HISTORIC AND DESIGN REVIEW COMMISSION

HDRC CASE NO: 2021-318
ADDRESS: 220 N MESQUITE ST
LEGAL DESCRIPTION: NCB 583 BLK 8 LOT W 66.11 FT OF 10
ZONING: RM-4, H
CITY COUNCIL DIST.: 2
DISTRICT: Dignowity Hill Historic District
APPLICANT: Brad Clawson/Elise Construction
OWNER: MACKMOORE GROUP LLC
TYPE OF WORK: Window replacement, fenestration modifications
APPLICATION RECEIVED: June 24, 2021
60-DAY REVIEW: Not applicable due to City Council Emergency Orders
CASE MANAGER: Edward Hall

Window Replacement Exhibit

220 N. Mesquite St., San Antonio, TX 78202

A-102

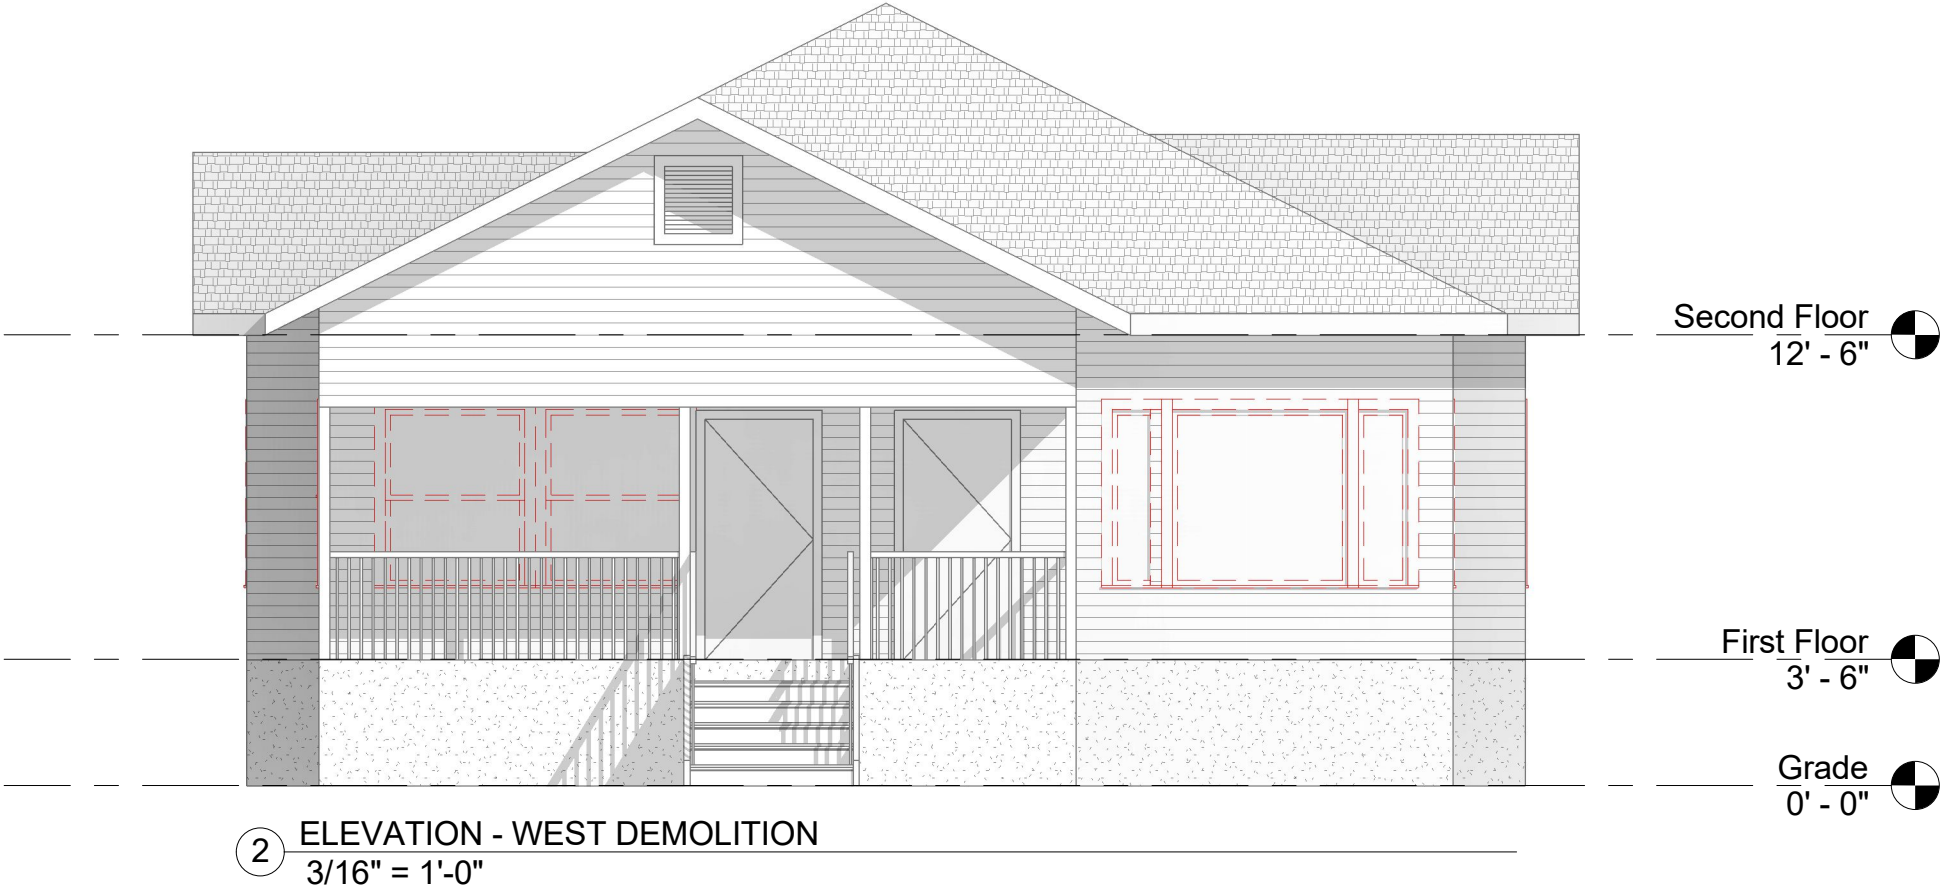
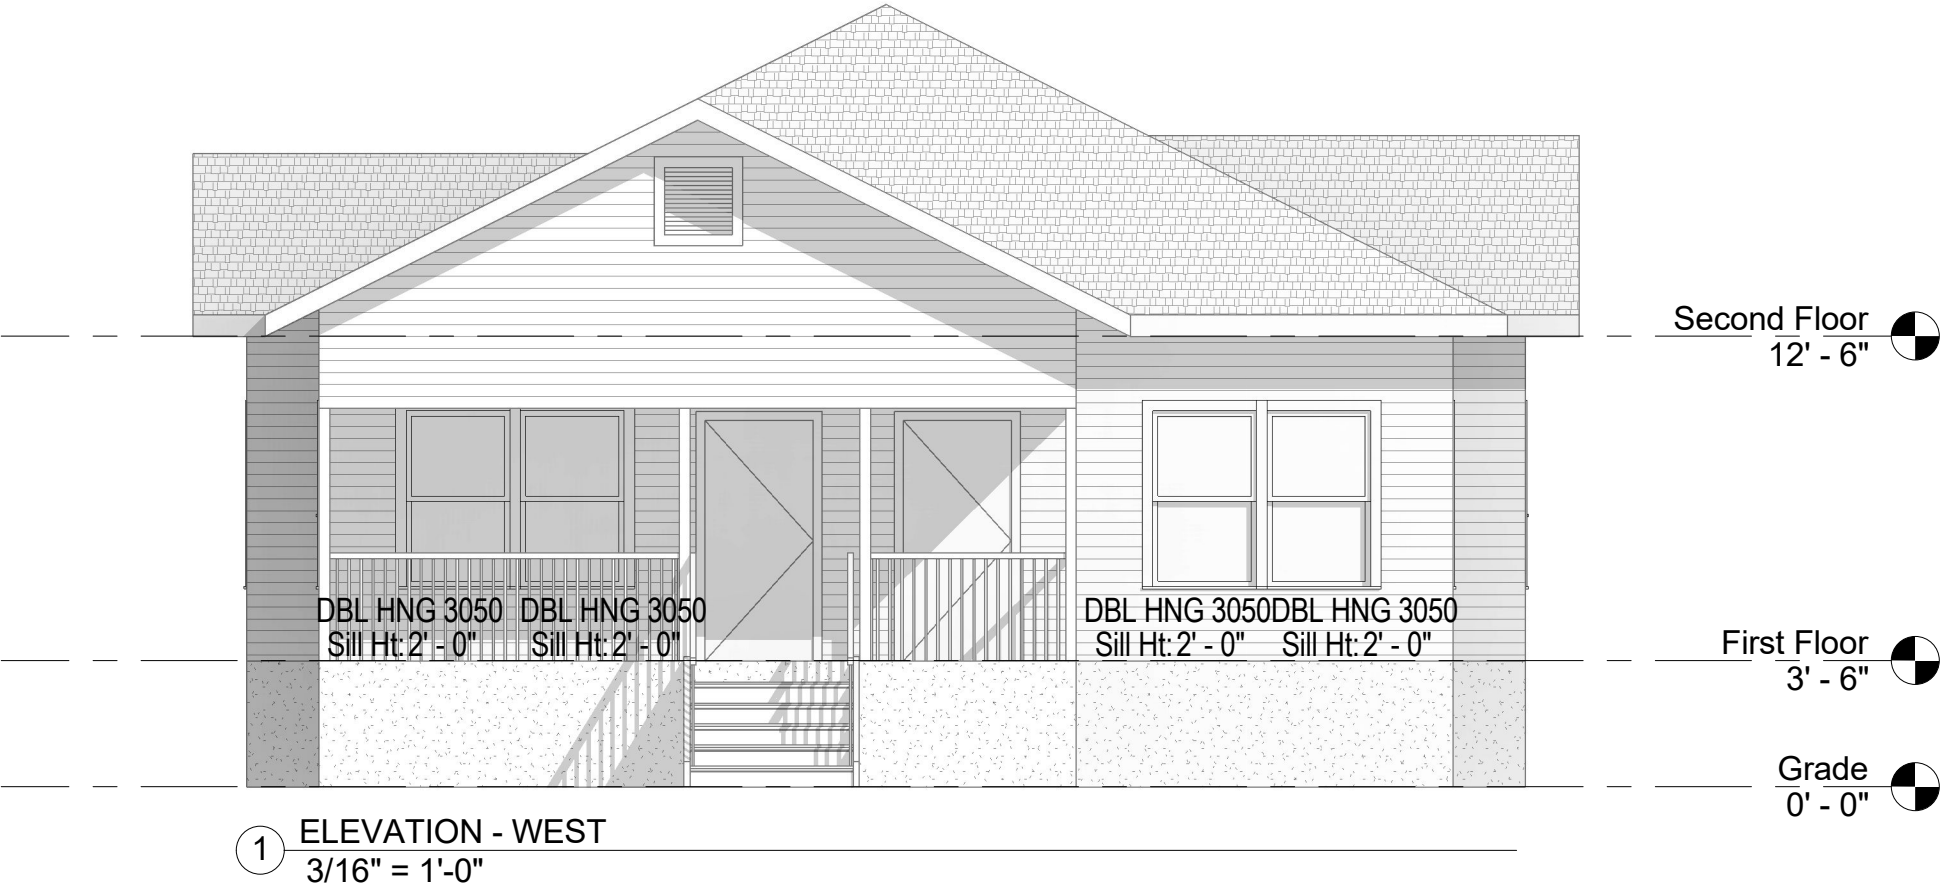
- b. **FRONT FAÇADE MODIFICATIONS** – The applicant has proposed front façade modifications to modify the existing, front window openings from their current form to feature grouped window with profiles that are generally consistent with those found historically on the structure. Generally, staff finds this modification to be appropriate and consistent with the Guidelines; however, staff finds that window widths, and head and sill heights should be consistent with those found on the historic structure. Grouped windows should be separated by a wood mullion of approximately six (6) inches in width.

1. Staff recommends approval of item #1, front façade modifications based on finding b with the following stipulations:
 - i. That the proposed window openings feature widths, and head and sill heights that are consistent with those found historically on the historic structure.
2. Staff does not recommend approval of item #2, fenestration modifications based on finding c. Staff recommends that all original window openings remain as they currently exist.
3. Staff recommends approval of item #3, aluminum window replacement with new aluminum windows based on finding d, with the stipulation that the proposed replacement windows be consistent with staff's standard specifications for windows.

A-103

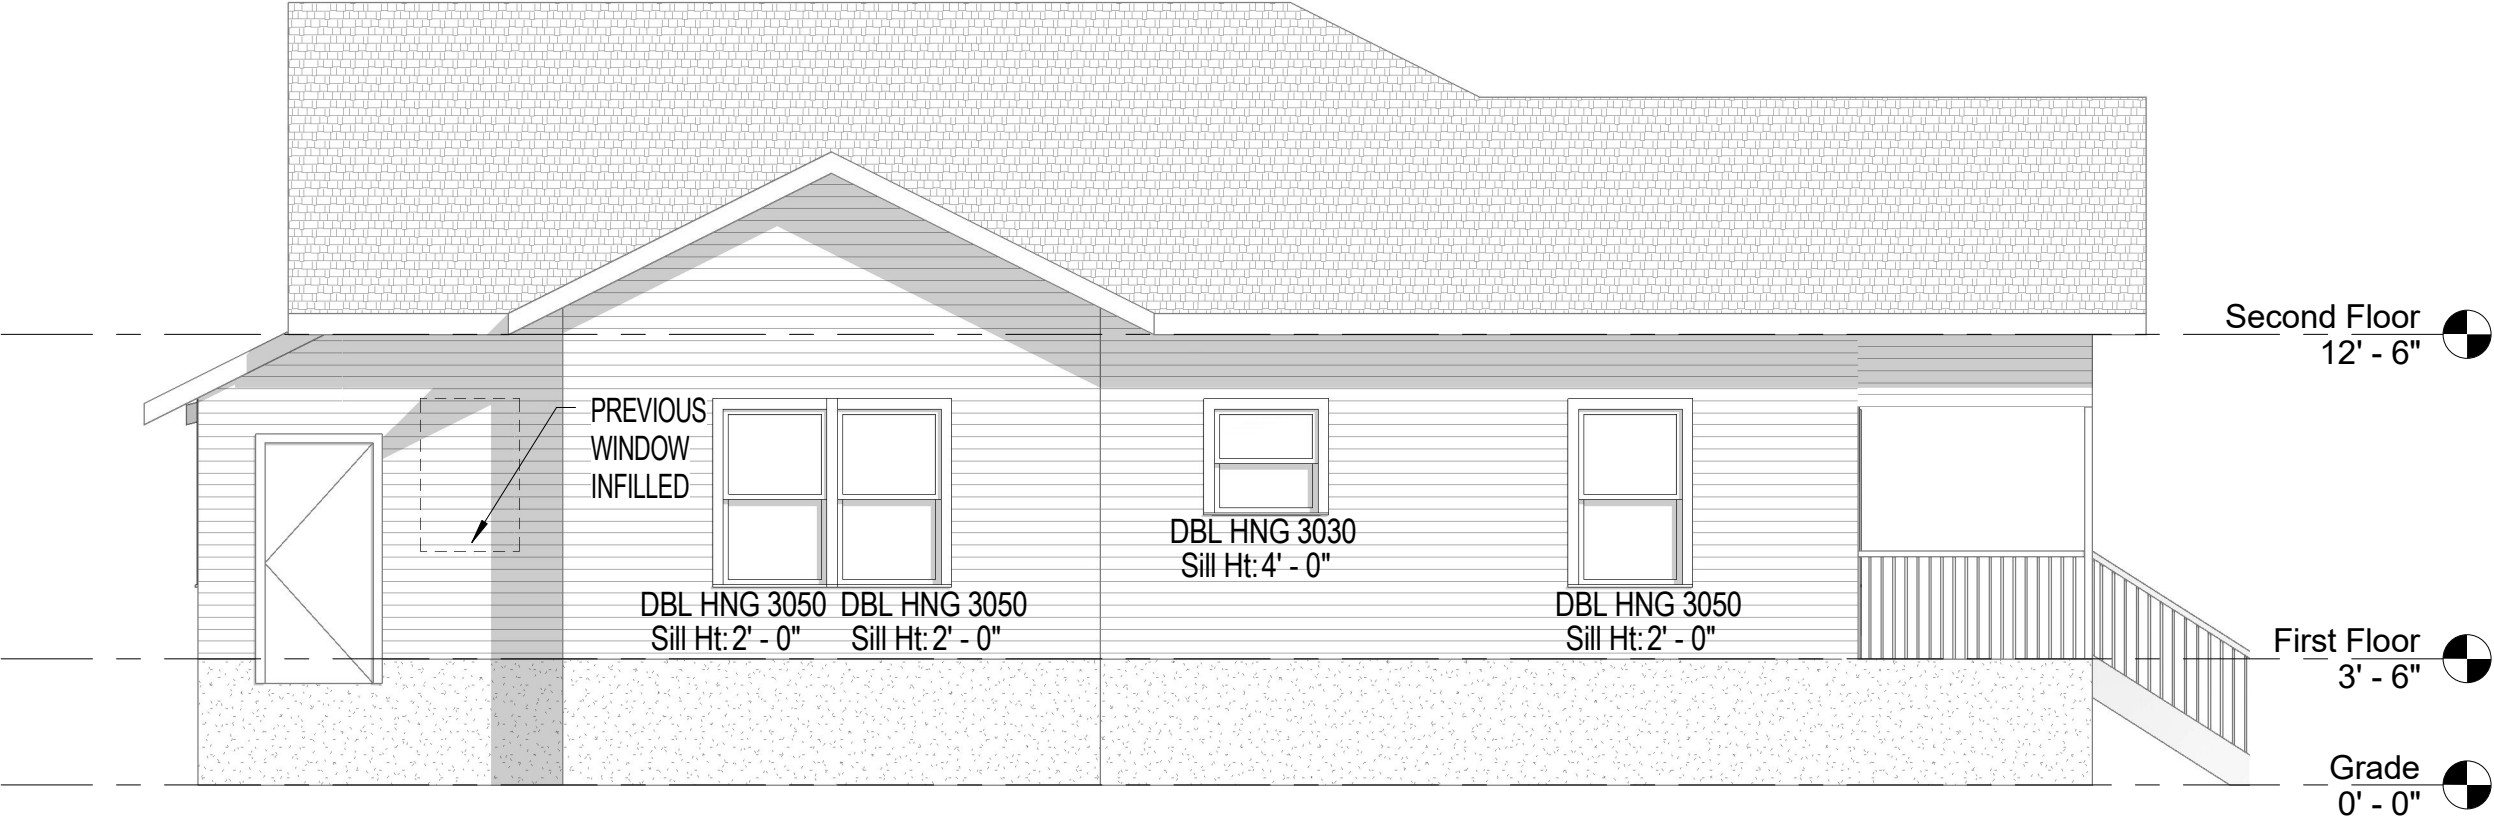
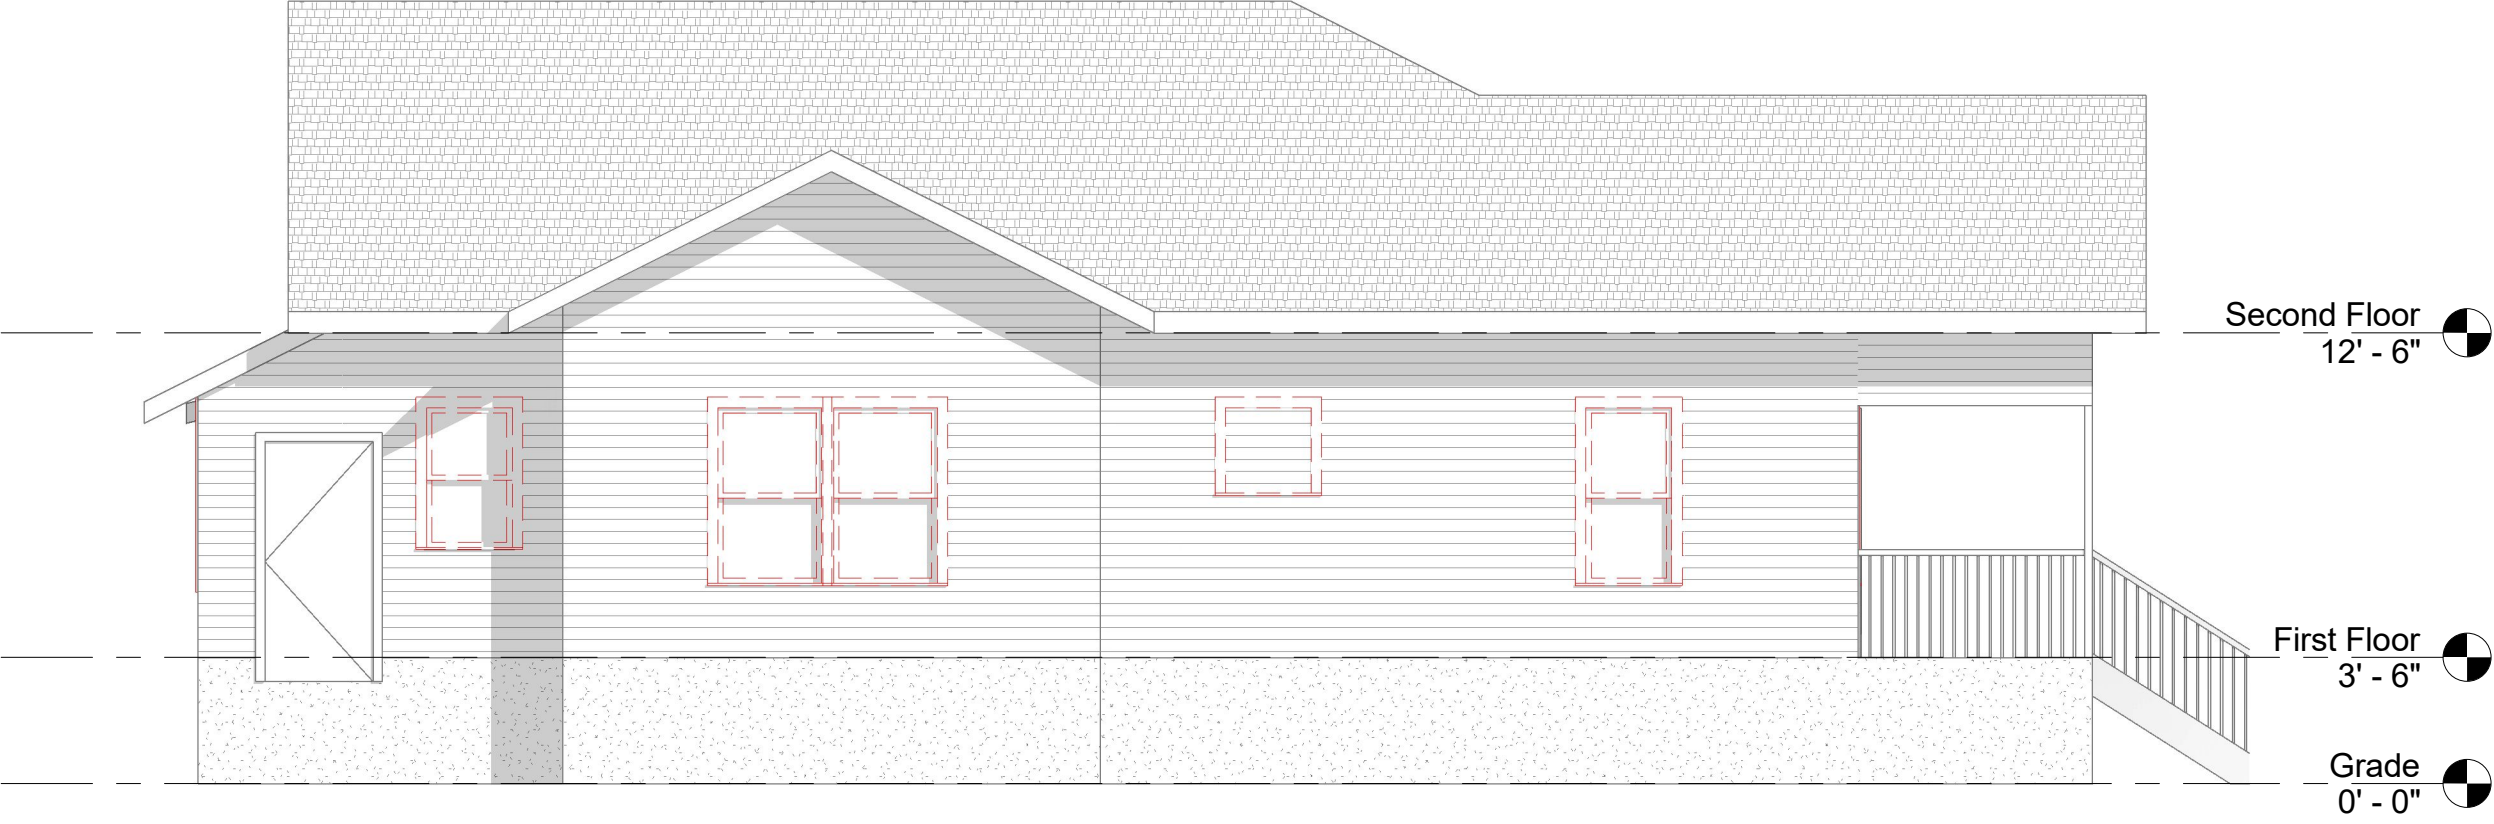
- c. **FENESTRATION MODIFICATIONS** – The applicant has proposed to remove two, existing window openings, one on the north façade and one on the south. Per the Guidelines for Exterior Maintenance and Alterations, 6.A.i., historic window and door openings should be preserved. Staff finds the proposed fenestration modifications to be inappropriate and inconsistent with the Guidelines.
